**CATHERINE CHAPMAN
WRITTEN REPRESENTATION**

**WITH REGARD TO THE APPLICATION BY HIGHWAYS ENGLAND
A428 BLACK CAT TO CAXTON GIBBET ROAD IMPROVEMENT SCHEME
(TR010044)**

**ON BEHALF OF MCDONALD'S RESTAURANTS LTD
McDONALD'S CAXTON GIBBET (STORE #1416) AND;
McDONALD'S WYBOSTON (STORE #543)**

Document: Written Representation

Figure 2A CD123 Design Standards for Junction Types

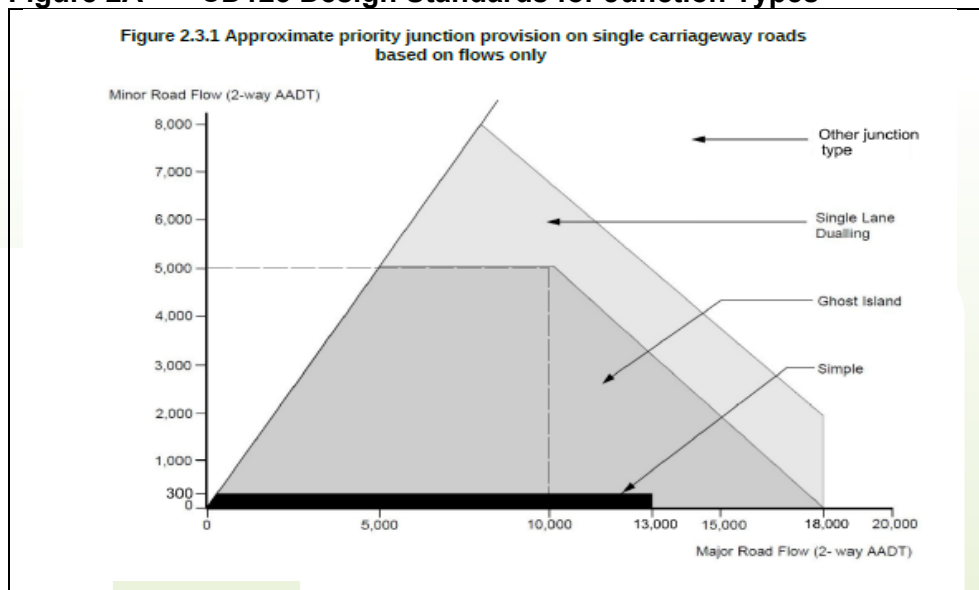
2.3.3 Design Manual for Roads and Bridges (DMRB); CD123 Geometric design of at-grade priority and signal-controlled junctions (January 2020) sets out Highways England design standards for junctions. As shown in Figure 2A below a junction with a minor road flow of more than 300 vehicles (AADT) would require a ghost island right turn lane junction to be provided.

2.4.1 The Highways England proposals for the Caxton Gibbet Roundabout are shown on the General Arrangement Plans Regulation 5(2)(O) Sheet 14 dated 05/02/21. The extract provided below as Figure 2B shows that the right turn lane facilities for the Service Area and the Self Storage/Agricultural Access would be removed. This would be contrary to CD123 Guidance for the Services Access arrangements.

Figure 3B Proposed Services Access Arrangements Wyboston

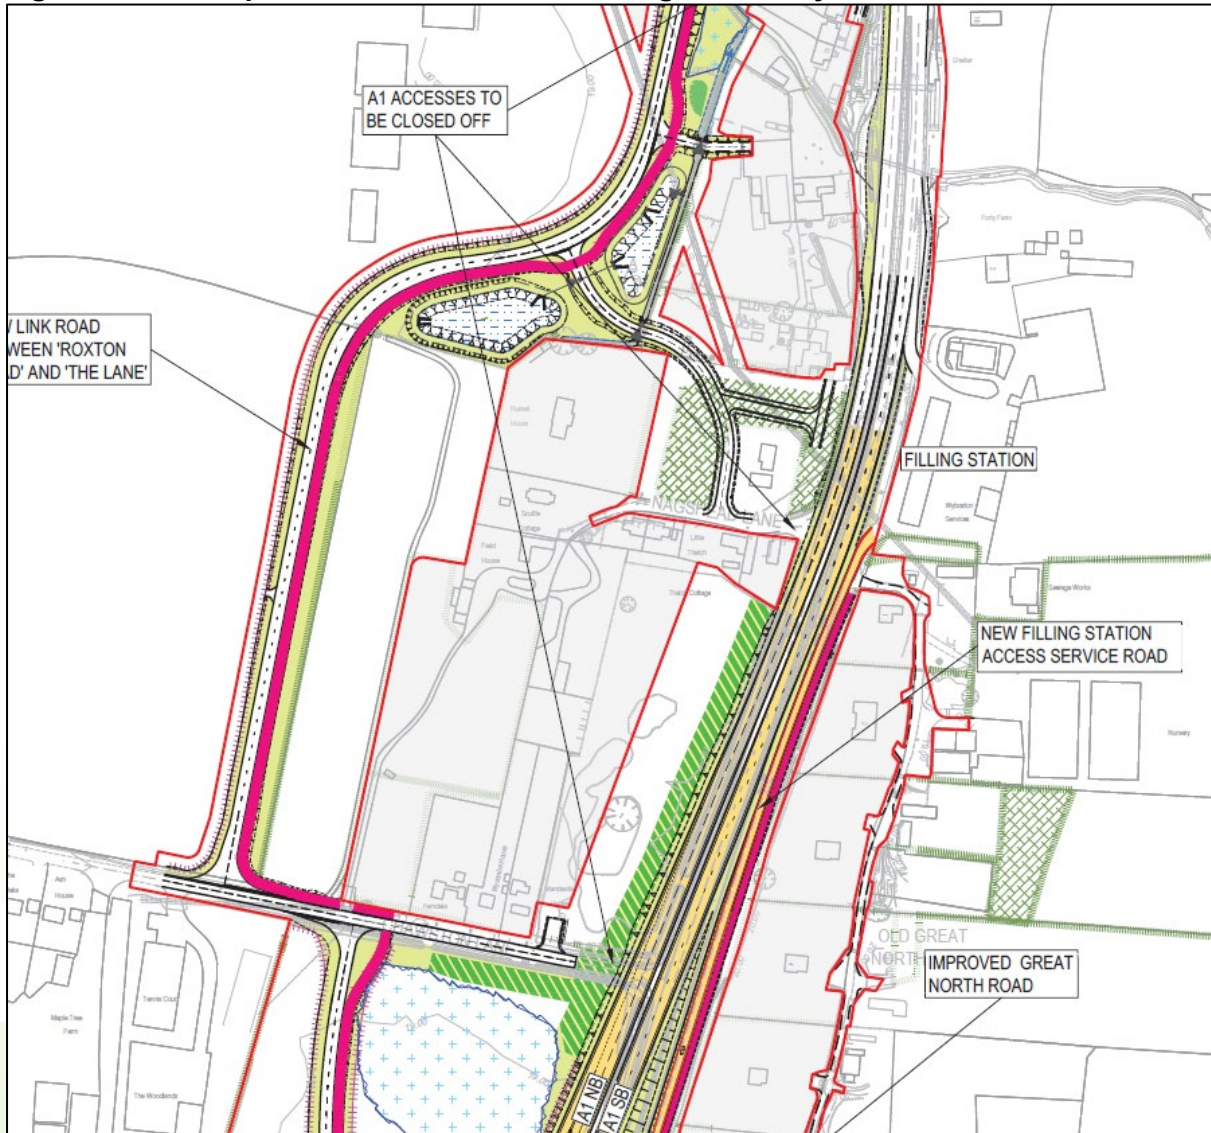
3.2.1 The Highways England proposals for the Wyboston Services are shown on the General Arrangement Plans Regulation 5(2)(O) Sheet 2 dated 05/02/21. The extract provided as Figure 3B shows that the access left in would be retained from the A1 (Southbound). However, the egress to the Services would be modified. There would be no direct egress to the A1. Customers would egress via a new access link running parallel to the A1 which would also serve Great North Road back to the Black Cat Junction.

3.2.2 No signage plans have been provided. It is considered that there would be a considerable distance for customers to travel before they get back to the A1. Appropriate and adequate signage needs to be provided to ensure customers are confident that they are being correctly directed back to the A1. In addition, signage is required to ensure customers do not try and access the restaurant from the Black Car Roundabout via Great North Road (i.e., try and enter via the egress having travelled 1km up Great North Road to find this is not an access route) which would be a highway safety issue.

- 4.3 No signage plans have been provided to support the Highways England proposal alterations to the egress of the Services at Wyboston. No information has been provided to demonstrate that customers will be informed on the egress route back to the A1 or that appropriate signage will be provided to ensure that customers do not try and access the restaurant via the new link.

**APPENDIX CMC 5.0
CAXTON GIBBET SERVICES
SIGNAGE REQUIREMENTS**

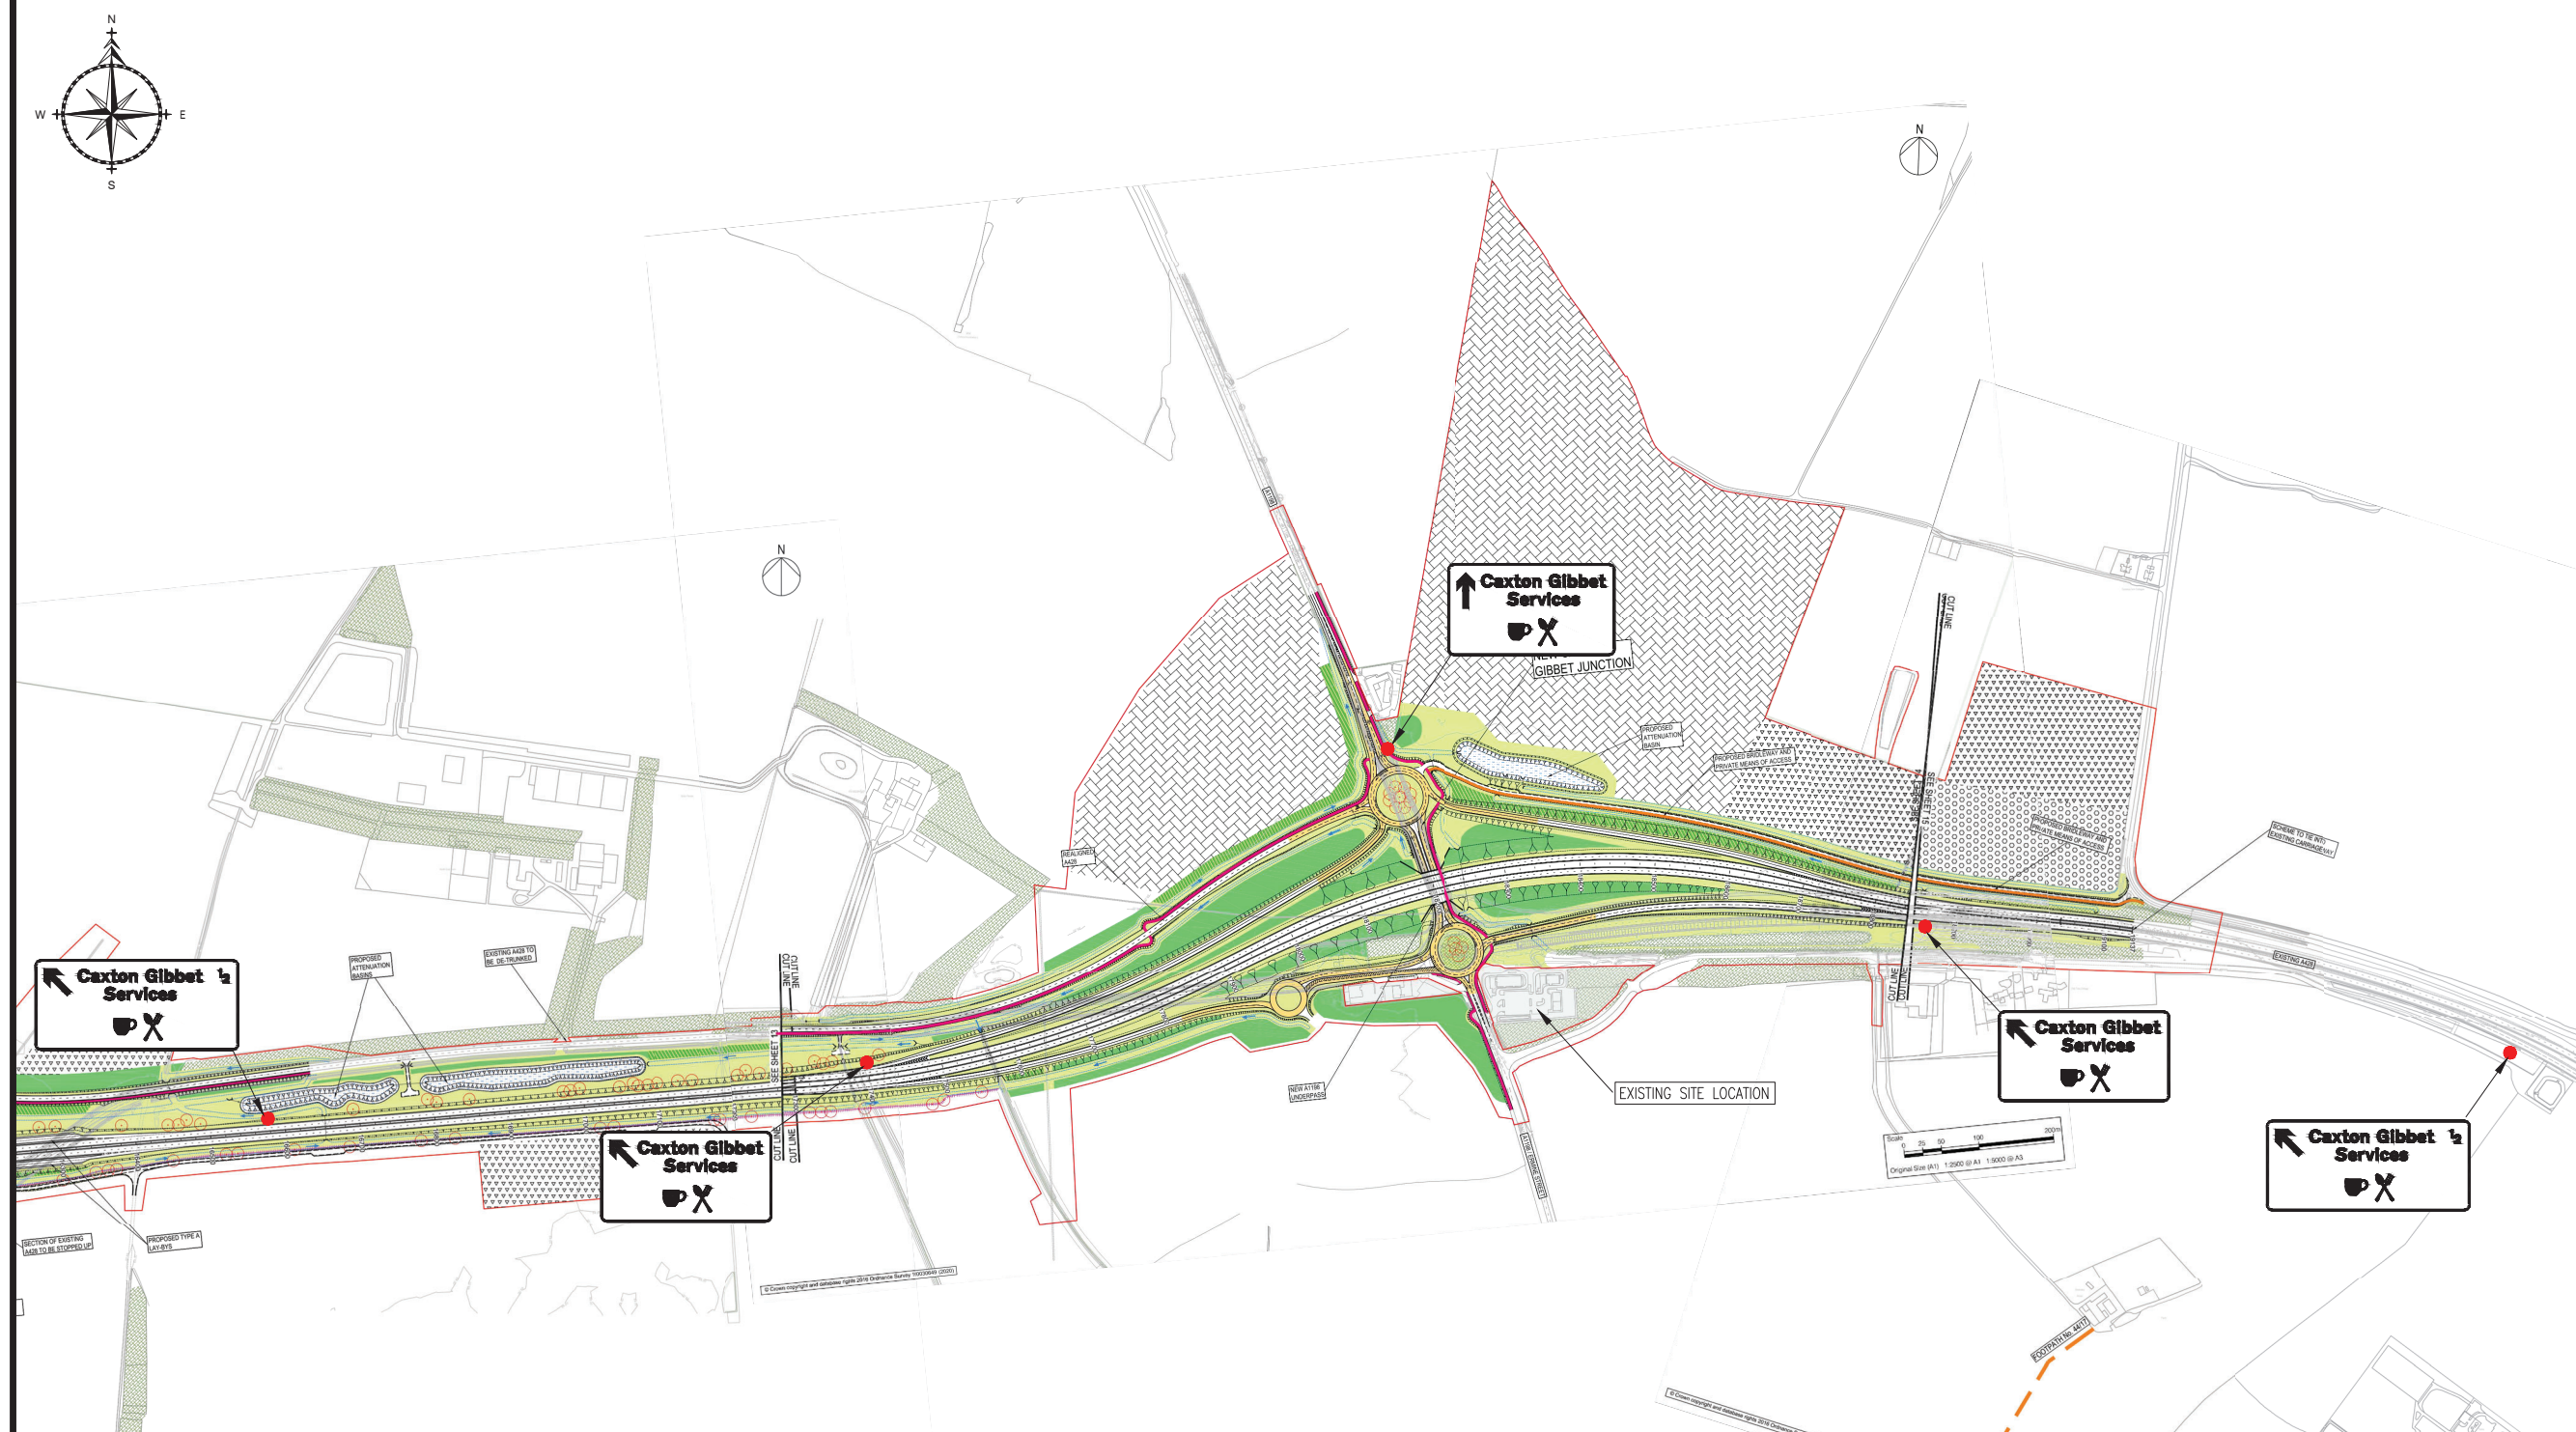
- 2.4.3 No signage plans have been provided to support the Highways England proposals. The proposed dumbbell roundabout arrangement requires customers to make a decision to leave the A428 via the slip roads much earlier than with the existing roundabout arrangement. Therefore, signage for the services will be essential to ensure motorists can make safe and timely decisions if they wish to visit the services. I have provided a plan showing the signage requirements we consider should be provided for Caxton Services as Appendix CMC 5.0.
